PCN# 20150821001

**Qualification of FFAB as an additional Wafer Fab site option for select devices in the
BICMOS13 process
Change Notification / Sample Request**

Date: 8/24/2015
To: MOUSER PCN

Sample product shipping label (not actual product label)

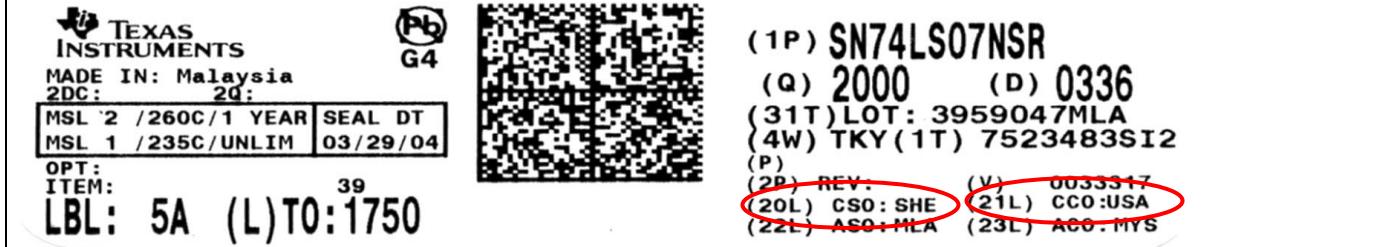
Changes to product identification resulting from this PCN:

Current

Chip Site	Chip Site Origin (20L)	Chip Site Country Code (21L)	Chip Site City
MAINEFAB	CUA	USA	South Portland

New

Chip Site	Chip Site Origin (20L)	Chip Site Country Code (21L)	Chip Site City
FR-BIP-1	TID	DEU	Freising
